**DEVELOPMENT ASSESSMENT PANEL
AGENDA FOR MEETING TO BE HELD ON
WEDNESDAY 4 MAY 2016**

DEVELOPMENT ASSESSMENT PANEL

Wednesday 4 May 2016

Agenda Ref No:	DAP040516 – 2.1
Originating Officer:	Alex Wright Development Officer - Planning
Applicant:	Mantrix Pty Ltd
Development Description:	Three two storey row dwellings and a single storey residential flat building, comprising two dwellings to the rear of the site
Site Location:	2 Ulva Avenue, Warradale
Zone:	Residential Zone
Policy Area:	Medium Density Policy Area 12
Application Type:	Category 2/Consent
Lodgement Date:	23/07/2015
Development Plan:	Consolidated – 19 March 2015
Application No:	100/2015/1300
Recommendation:	That Development Plan Consent be GRANTED subject to conditions

Image 1: The footprint of the proposed dwelling in comparison to the previously-approved dwelling. Note: Footprint of previously-approved dwelling has been ‘flipped’ to provide meaningful comparison).

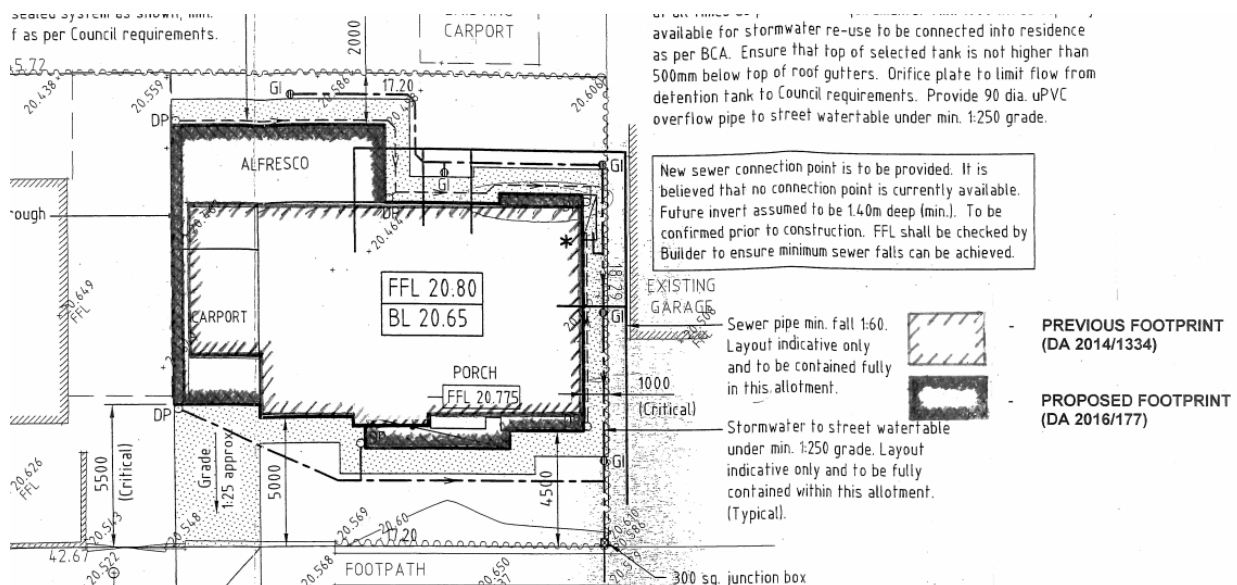
The proposed dwelling seeks for reduced setbacks than previously approved. The dwelling now proposes an under-main-roof carport abutting the northern side boundary, where previously the carport was setback 600mm from the (southern) side boundary (the design of the dwelling has been ‘flipped’), and enabling some (albeit limited) landscaping adjacent the boundary. The front setback has been reduced, with a minimum setback of 4.5 metres proposed, whereas the previous dwelling incorporated a 5.0 metre setback. The carport is now proposed to be setback at 5.5 metres, which previously measured 7.3 metres. Furthermore, site coverage has increased from 39% to 52.2%.

In my view, the reduced setbacks, although not significant in isolation, result in the dwelling being placed on the allotment in conflict with those parts of the Desired Character that seek for *“the maintenance and enhancement of the generous and vegetated garden character...”* and *“[b]uildings [to] be well setback from all property boundaries...[with] [f]ront and side garden landscaping [being] particularly important and should complement and reinforce street tree planting to help enhance the leafy, garden suburb character and the visual separation between houses”* (my underline).
